Corrigendum - 01

Minutes of Pre Bid Meeting

Tender No: 04/SE/Civil/2023-24

Name of the work: Supply, installation testing & commissioning of additional 2x10kl Liquid Medical Oxygen (LMO) Tank & allied work at AIIMS Rishikesh.

"Annexure-01"

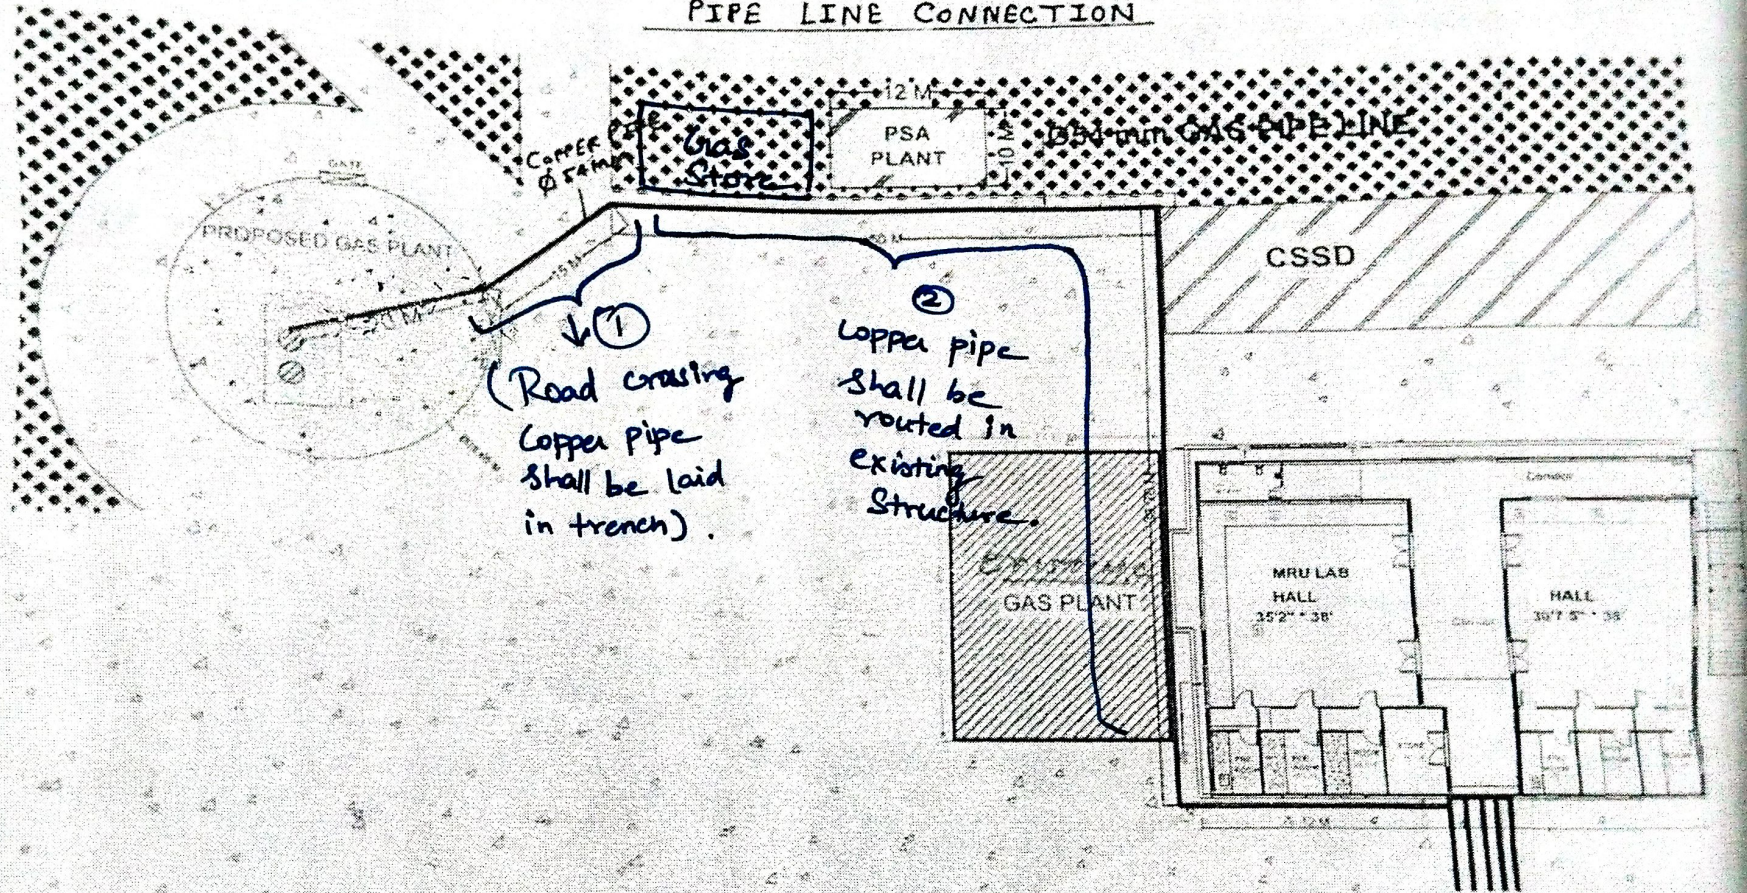
7	Copper pipe routing through trench and overhead piping shall be mentioned in layout for better understanding.		Copper pipe routing through trench and overhead piping shown in layout as " Annexure-01" for better understanding.

①
(Road crossing
Copper pipe
shall be laid
in trench).

②
Copper pipe
shall be
routed in
existing
structure.
